RE: Status of CU 24-01, DR 24-01, & ZA 24-01 "US Market gas station" at 2115 Molalla Rd (Tax Lots 051W09B001000, 1100, & 1200 [primary])

Staff reviewed the degree of completion of the Conditional Use (CU) consolidated applications package for the subject property with materials submitted January 23, 2024 with revised and additional materials received March 22 (electronic) & 25 (print) and April 1 (TIA) & 17 (site plan), 2024 and determined it incomplete as of April 19, 2024. Staff sends this letter to demonstrate compliance with Oregon Revised Statutes (ORS) [227.178\(2\)](#).

"Figure 1: Queuing Area

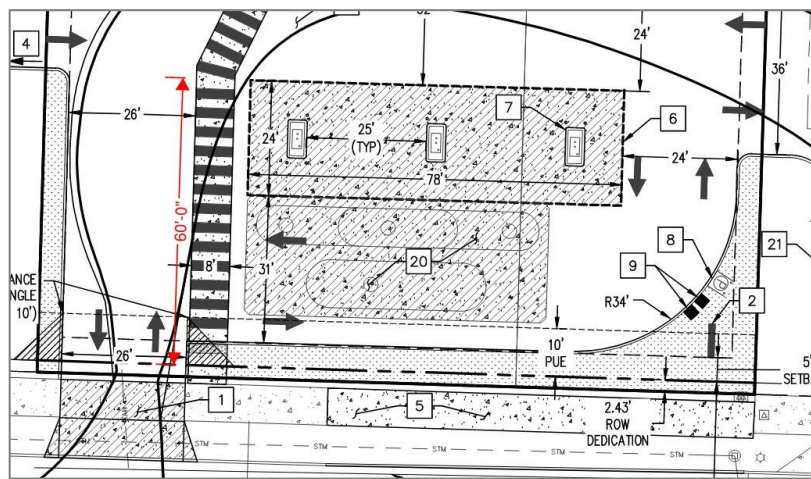
"This project involves the construction of a small-scale gasoline station. Typically, such establishments do not require excessive dedicated queuing space due to the specific characteristics of their operations and customer behavior. In contrast to larger discount or membership-based gas stations like Fred Meyer and Costco, where lengthy queues are common due to high customer volumes and competitive pricing, smaller gas stations generally cater to a more localized customers with lower traffic volumes resulting from pass-by trips. Customers at small gas stations are inclined to stop only if they perceive that their wait will be brief, thereby minimizing the need for extensive queuing areas.

Upon entering the site via the driveway, customers typically proceed directly toward the convenience store. The proposed design includes six fueling spaces and approximately 60 feet of available queuing area (refer to Figure 1), which would accommodate approximately three additional vehicles. No queuing concerns are anticipated. This item is complete."

The response doesn't address the item and guiding questions, particularly Question 3.

**C100**

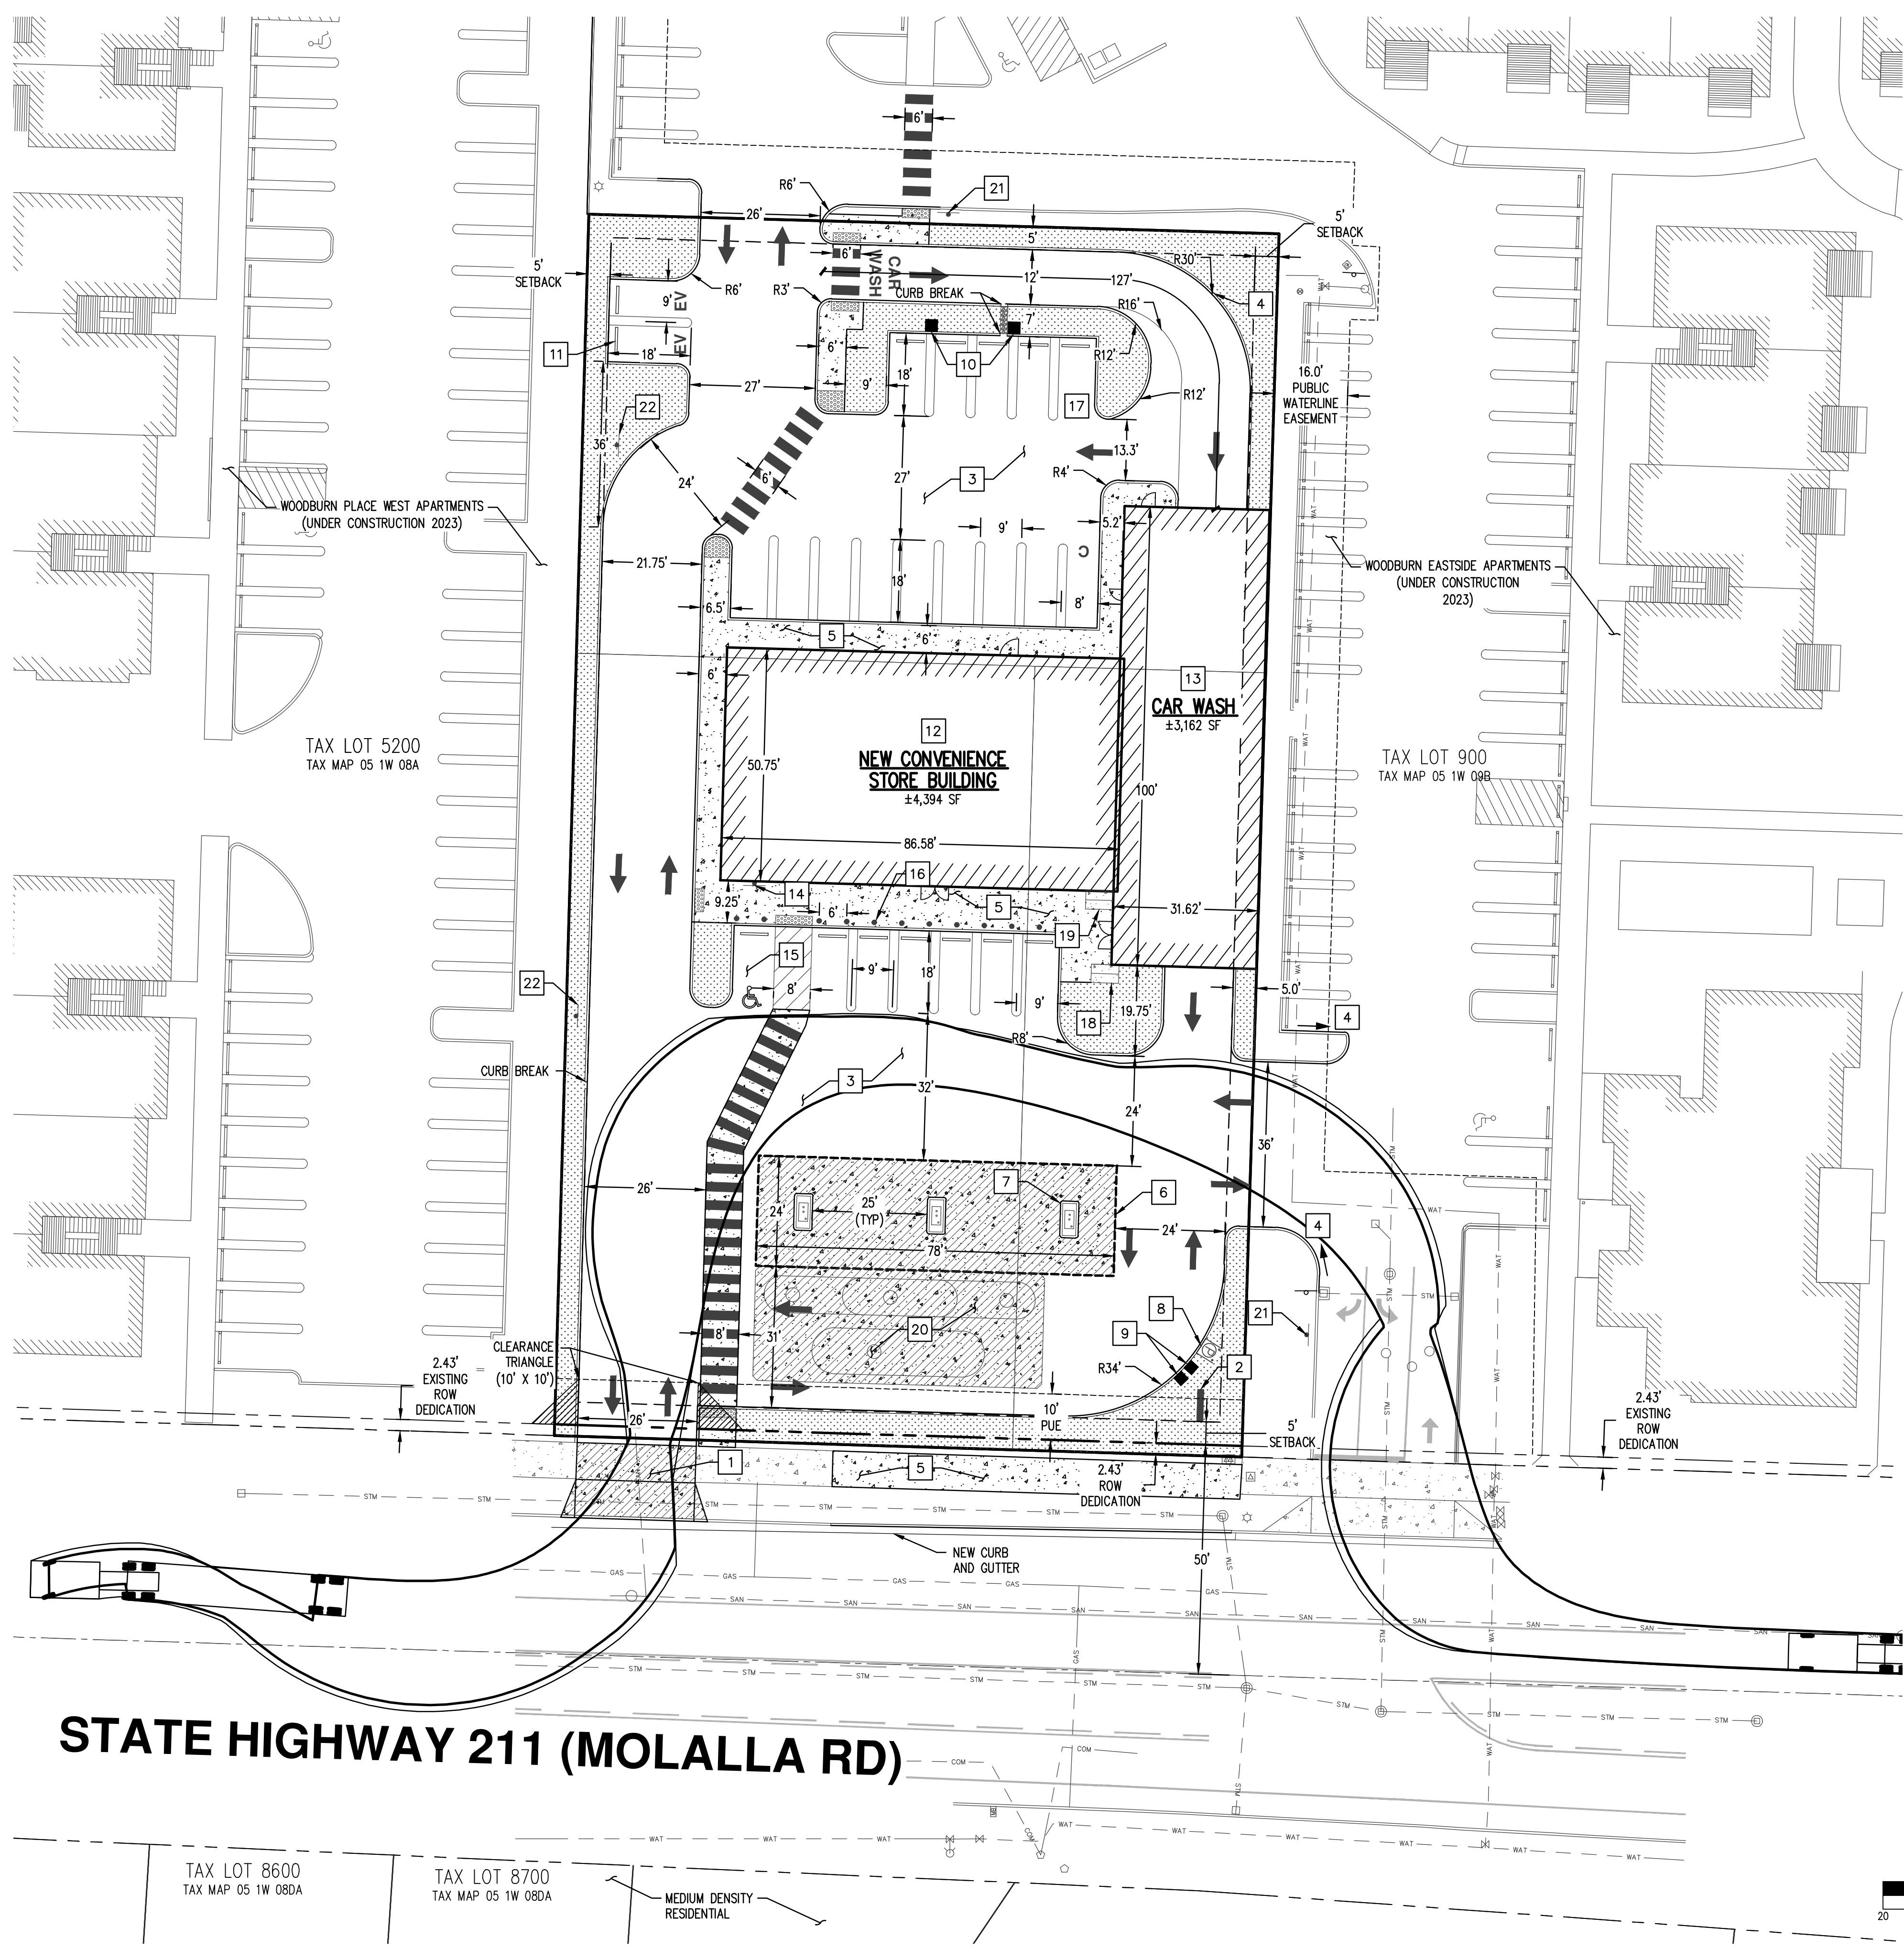
The site plan (Sheet C100) illustrates turning movement that doesn’t need 26 ft of width, and in any case the description above doesn’t affect the applicability of the WDO standard.

Note: Zoning Adjustment (ZA) of maximum driveway width to 26 ft is permissible per 5.02.06C.19c – with a [ZA application](#) including a revised [uniform application form](#), ZA fee payment of \$3,520 per the [Planning Division fee schedule](#), and application materials that address the factors and meet the criteria of 5.02.06B; however, staff doesn’t see how a proposal could meet criteria 1, 3, & 5 and would be disinclined to recommend approval.

Revise the site plans (or apply for ZA).

**L100**

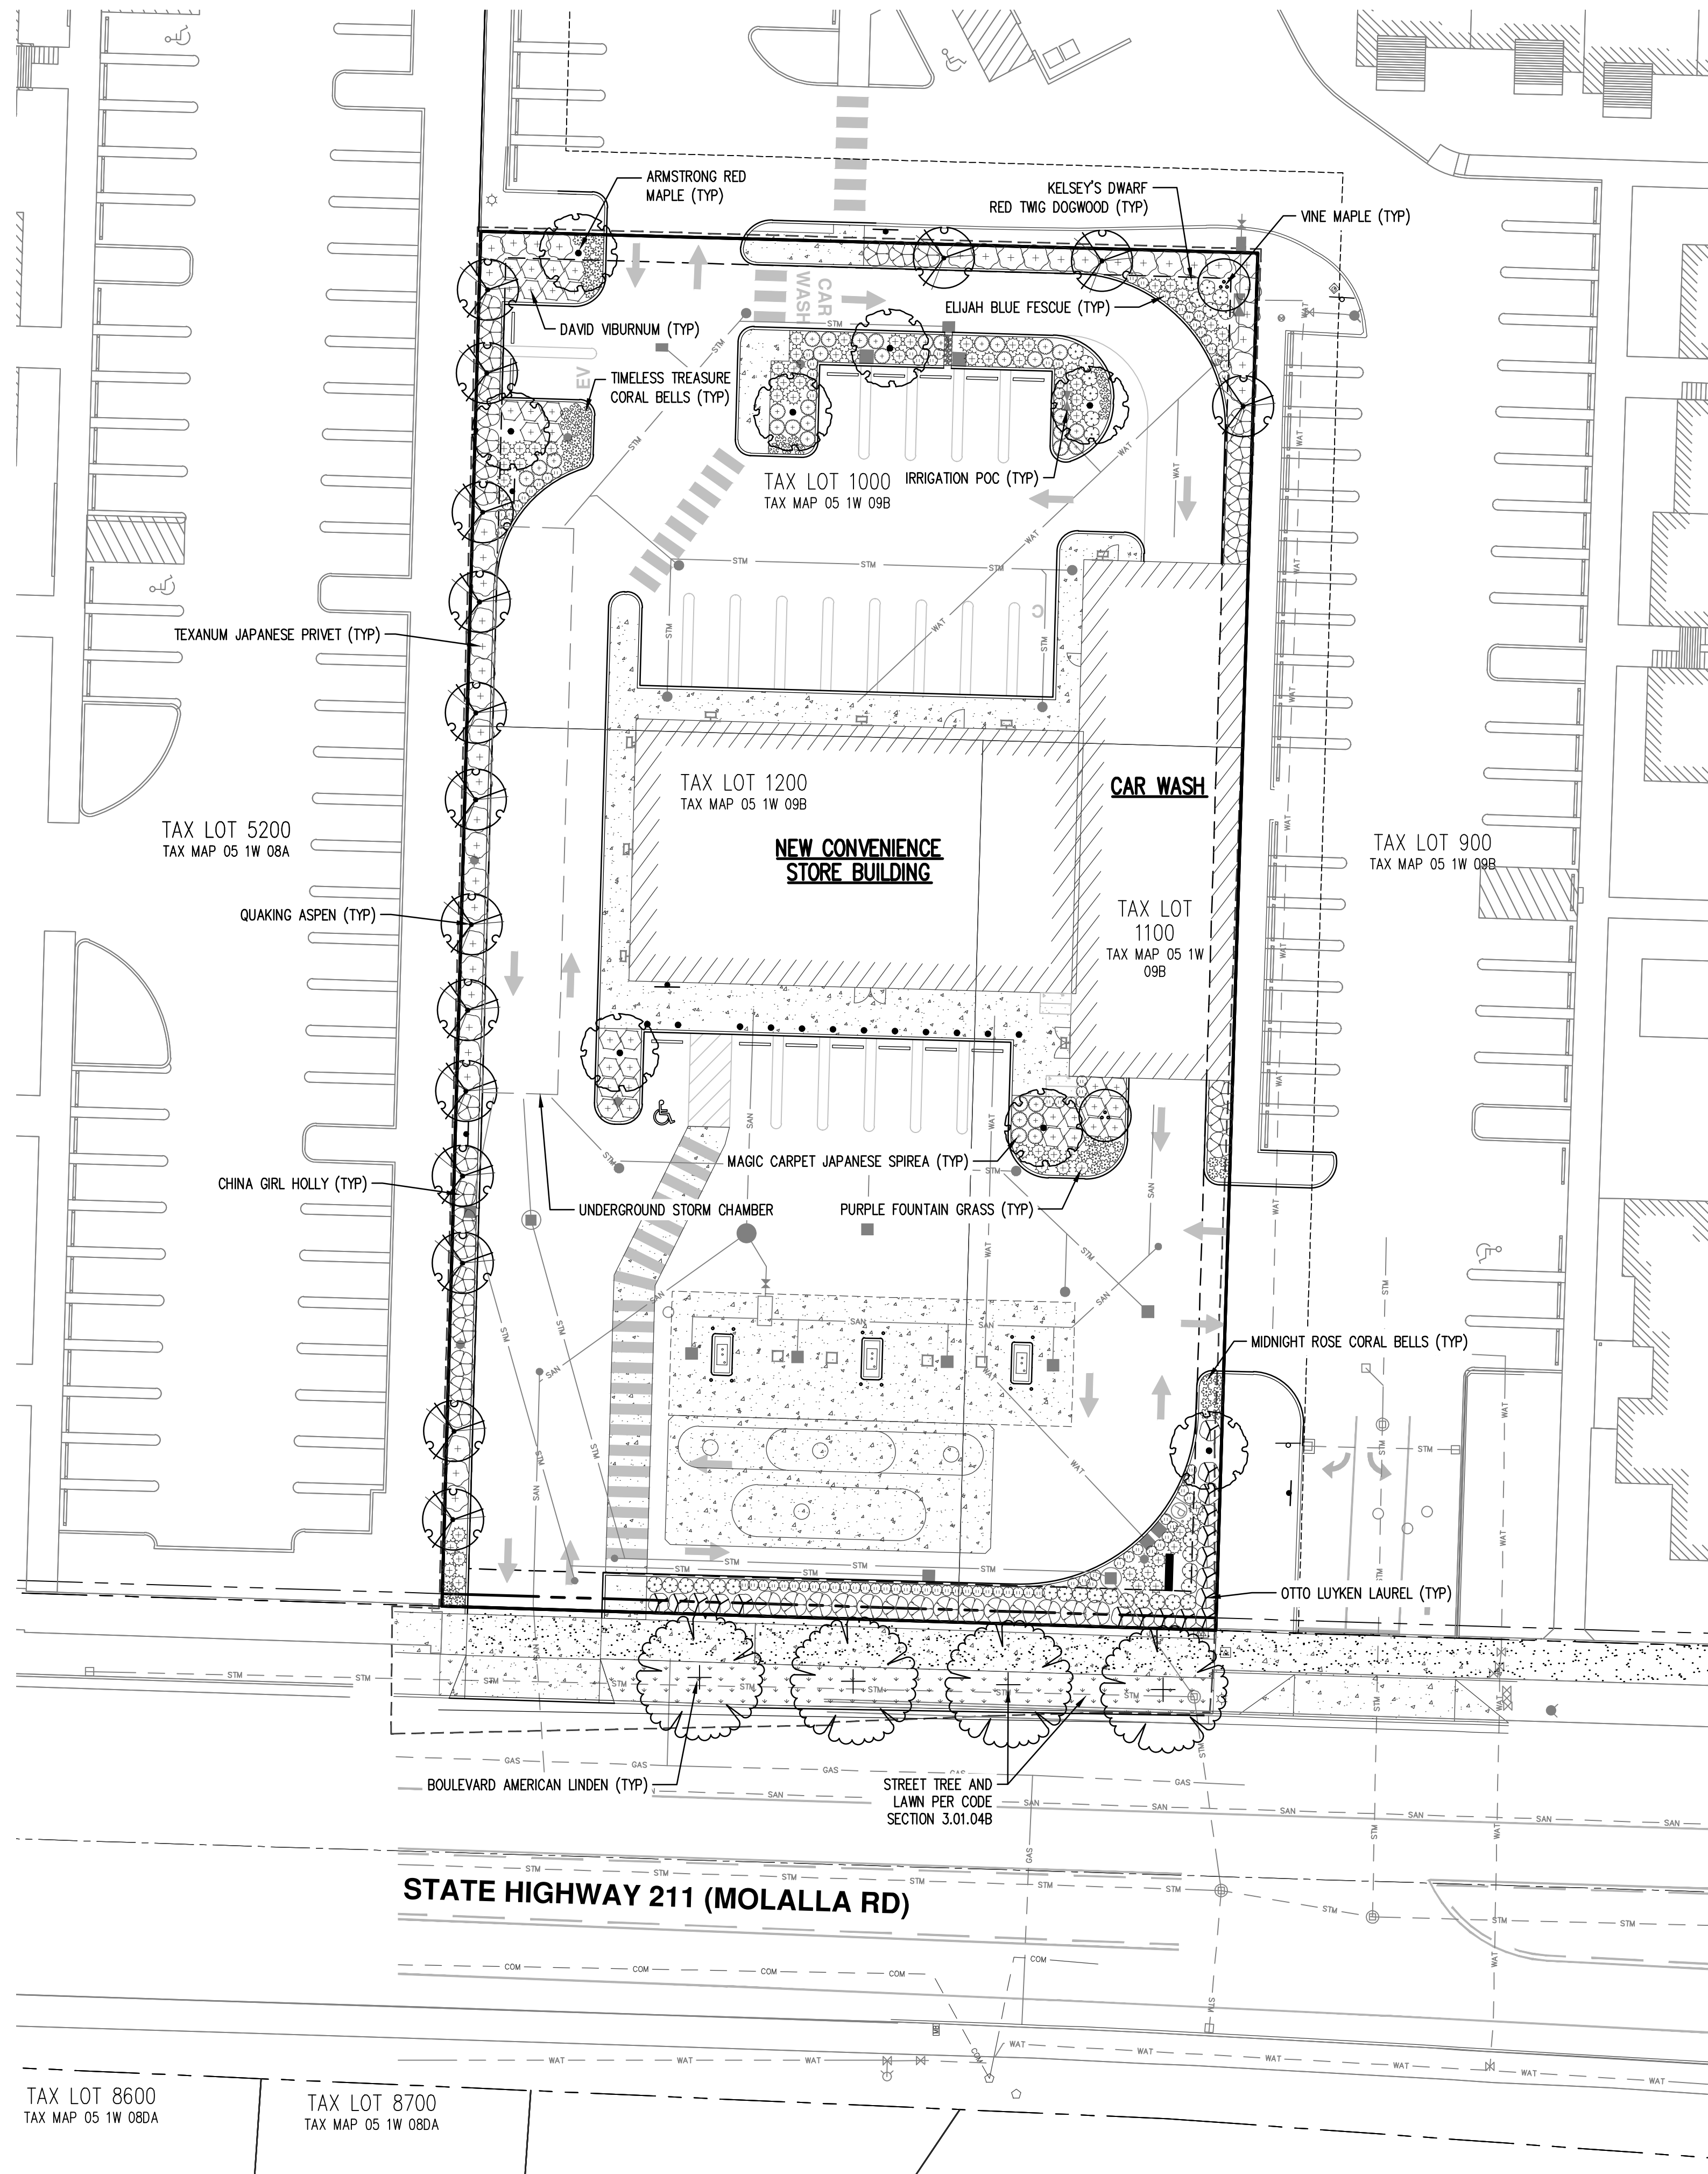
The revised landscape plan (Sheet L100) illustrates and notes the proposed street species as one reaching a mature height of 45 to 50 feet (ft). WDO Table 3.06B row 3 defines medium size category at maturity as 40-60 ft height.

3.06.03A.2a requires along the highway, which is “Major Arterial” class, large trees. Table 3.06B row 2 defines these as 60-120 ft height.

Revise the street tree species to a large one.
